Response to Visual Impact and View Loss Issues raised
by City of Sydney

**STAR CITY CASINO -
Multi Use Entertainment Facility**

GM Urban Design & Architecture Pty Ltd
January 2011

Before and after photomontages showing the impact of the proposed MUEF facility from the Heritage Walk

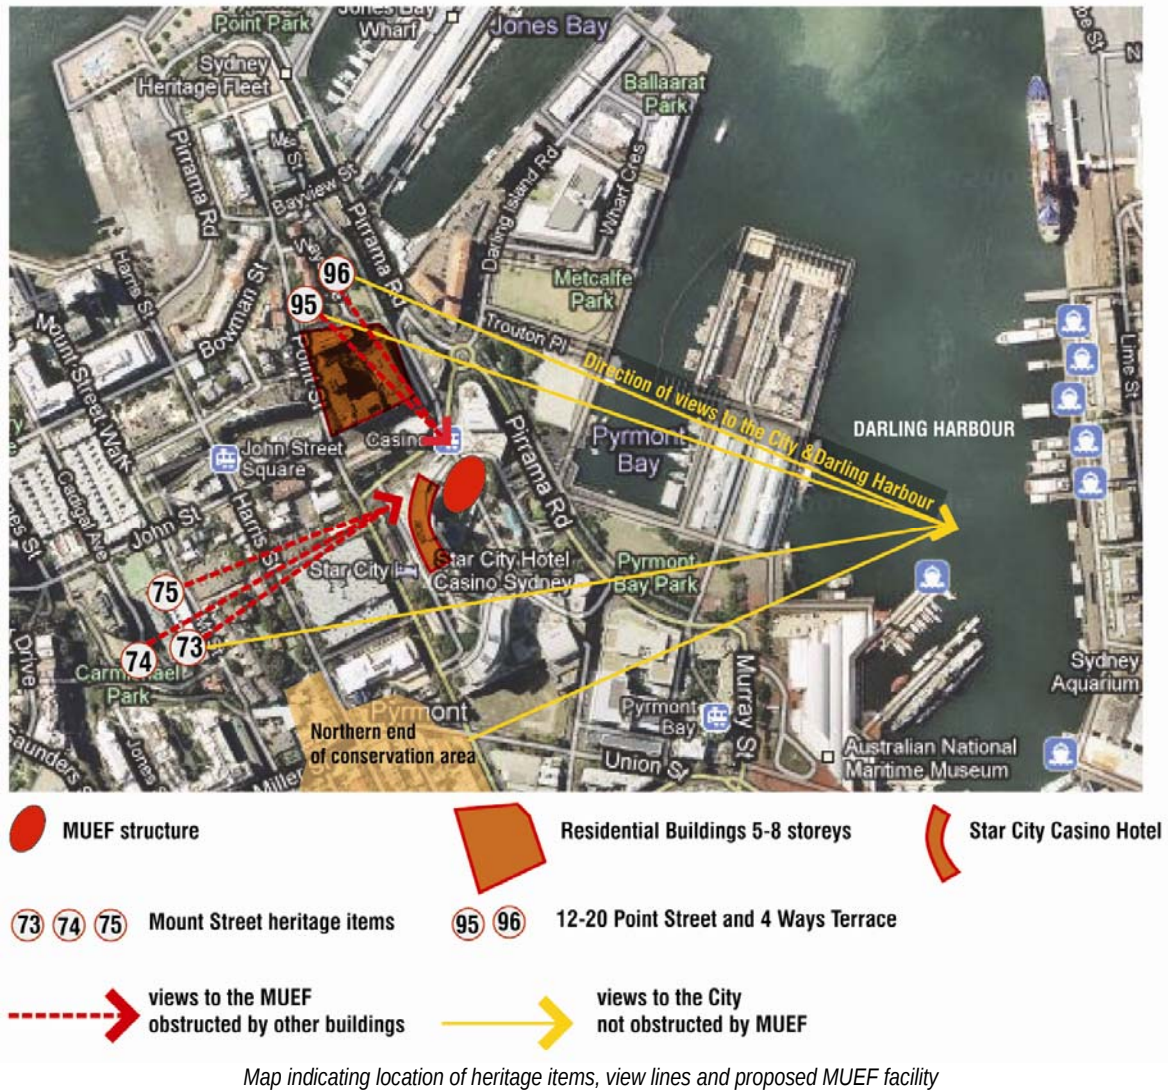
The CoS considers "that the proposed MUEF will have a detrimental impact on views from the Heritage Walk" as it is "directly on axis with the walkway and occupies a large portion of the sky terminating the current expansive views across and above the existing Casino building". As the updated before and after images show below, the proposed MUEF is indeed on axis with the walkway and will be visible from this location, however as the pictures show, the proposed MUEF will not occupy a larger portion of the sky nor will it have a detrimental impact on expansive views across and above the existing Casino building. Nevertheless, further changes have been made to its form and shape to ease its overall volume as well as changes to its materiality to add interest to the elevations and further articulate its apparent bulk and scale. As shown in the pictures below, the structure blends with the surrounding structures and a substantial portion of sky will be visible above the structure; therefore this is an acceptable outcome.

Furthermore, it can be argued that the proposed structure reinforces the existing and ever-changing character of Pyrmont and Ultimo which is characterised by a juxtaposition of heritage development with new contemporary development.

Map 10. Significant Places and View Corridors (Courtesy of City of Sydney)

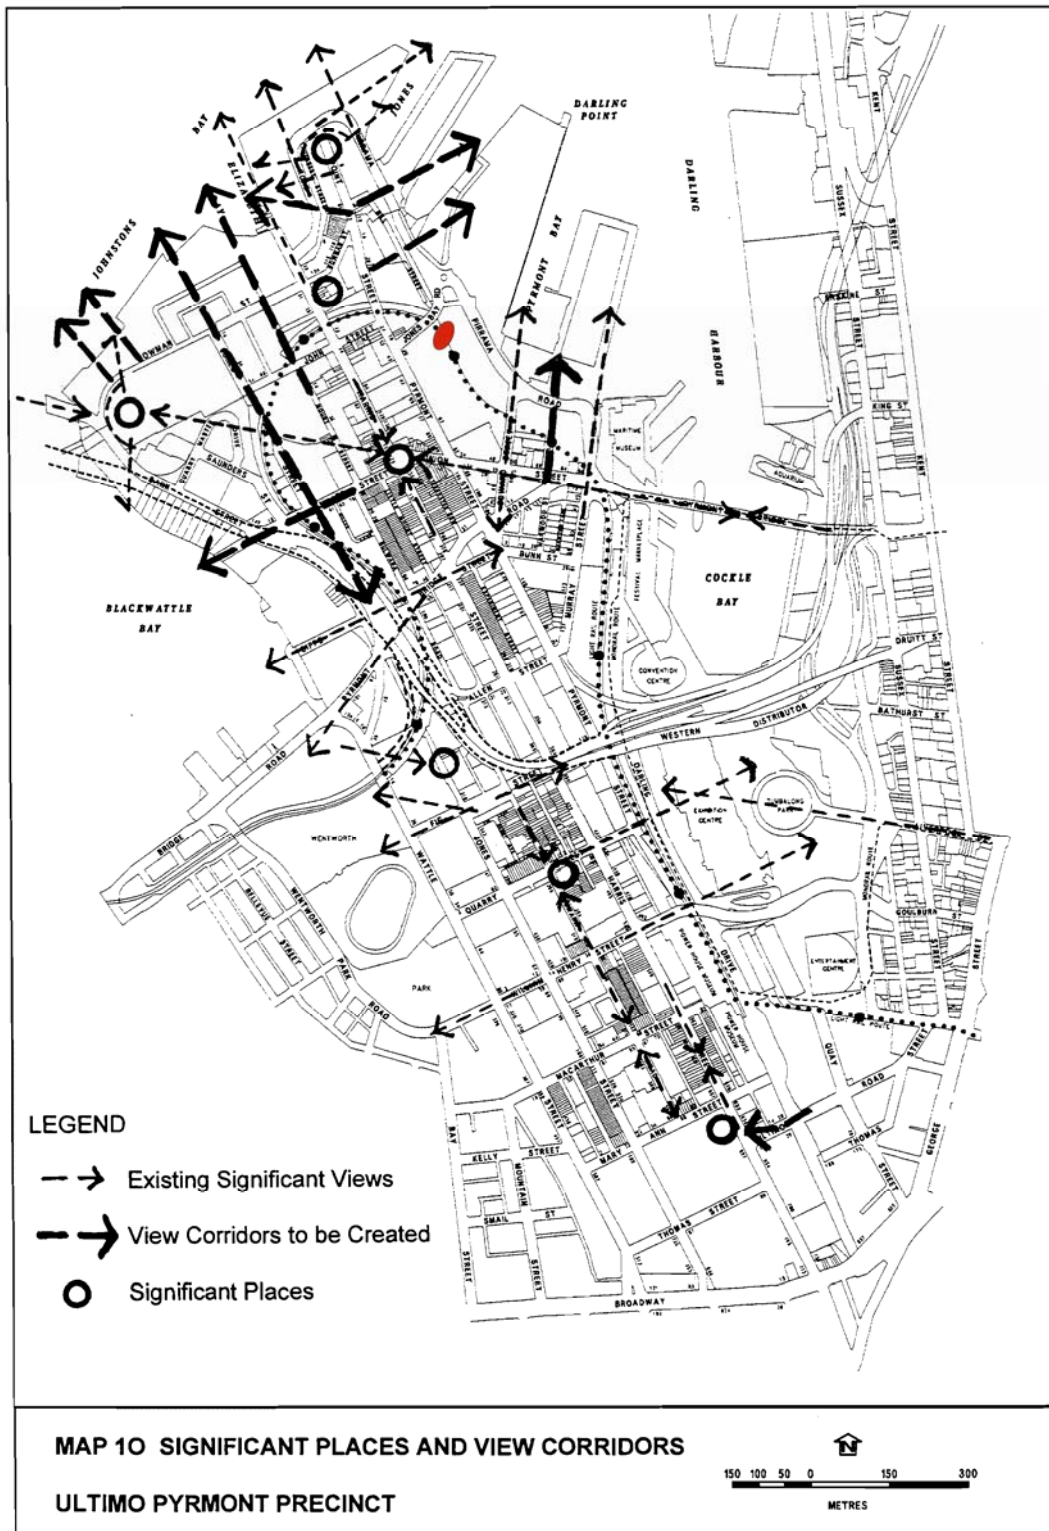
The CoS submission states that the proposal will be seen at ‘relatively close range’ in the context of the medium range views from Harris Street at the northern extremity of the conservation area, from Mount Street and Ways Terrace restricting views across Darling Harbour. The map and studies provided below show that none of the nominated views look across the proposed extension towards Darling Harbour and the CBD. In fact, there is no possibility to view the proposed Star City Extension from the above mentioned heritage items because of the existing taller buildings that obstruct the view line as shown on the following map.

It is important to emphasize that all major views and vistas and view corridors to be maintained or created in the Ultimo and Pyrmont precinct are shown in the map below (Map 10) which is an abstract from the UDP. The map clearly shows that the proposed facility extension (indicated as a red ellipse on the map) does not obstruct nor is in the path of any of the existing significant views or view corridors to be created.

Furthermore, no views to significant places as shown in the map appear to be affected and the new changes to the design, form and materials of the MUEF help to create a more sculptural and articulated facade which will add interest from short and long distance views and will contribute not only as an attractive part of the Star City Casino complex but also as another point of interest to be added the overall skyline and character of the area.

3d model view showing the control height and proposed development as seen from level 7

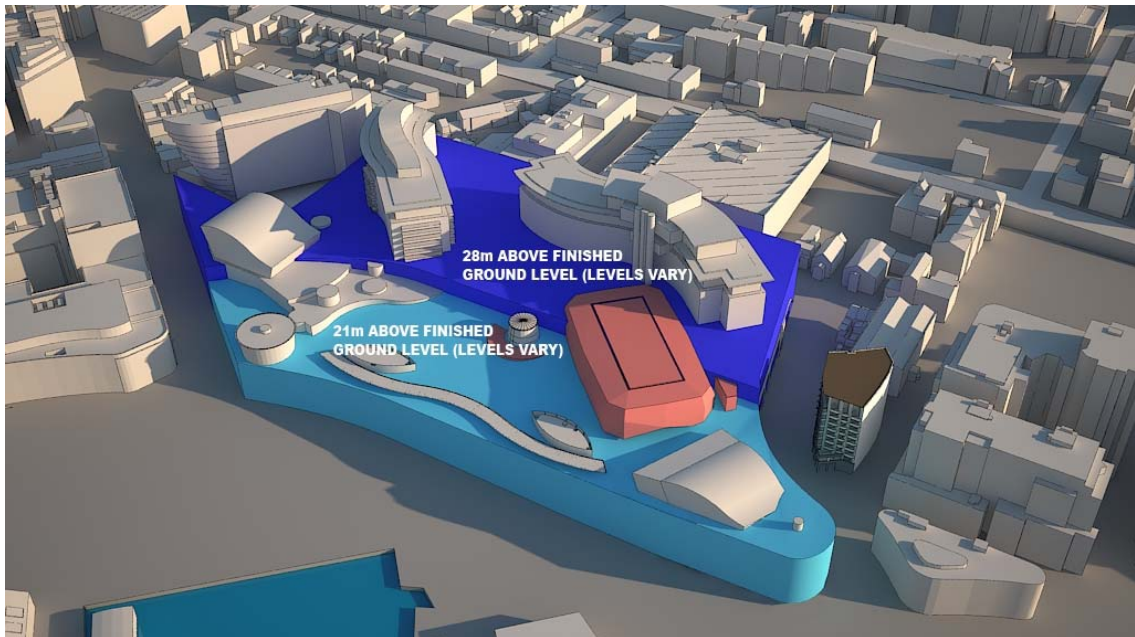
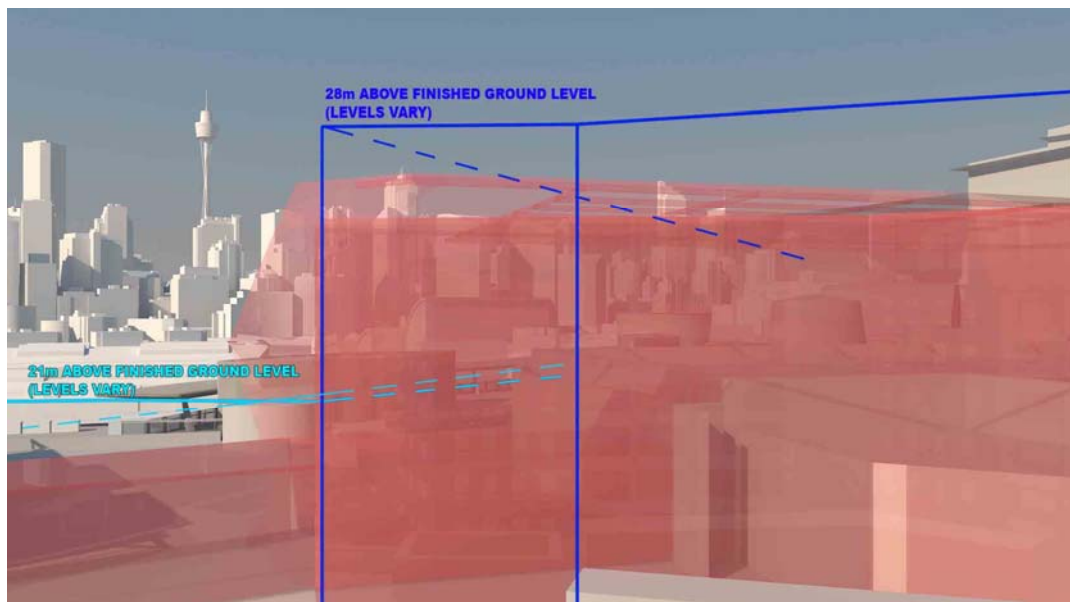
According to the CoS, “the proposal will result in the loss of views currently enjoyed by existing residential apartments on floors 3 to 8 facing south east at 2 Jones Bay Road.” According to the submission by the City, the impact to apartments located on level 5 and above is “considered significant”. It is the City’s opinion that, the extent of non-compliance with the height controls has not been accurately presented as a result of adopting only the (higher) ground level RL of Jones Bay Road.

The views from level 7 are at a level that arguably may or may not be affected by a compliant proposal subject to the extent of structure above the maximum ceiling height. The proposed facility massing will affect the available views, but this impact is less than that of a fully compliant development.

The proximity of the 28m height envelope built to the street (as seen on the axonometric view below) results in a compliant development that would potentially obscure this view. Therefore, the proposed envelop has less viewing impacts than a fully compliant development as it is contained far below this line as viewed from this level.
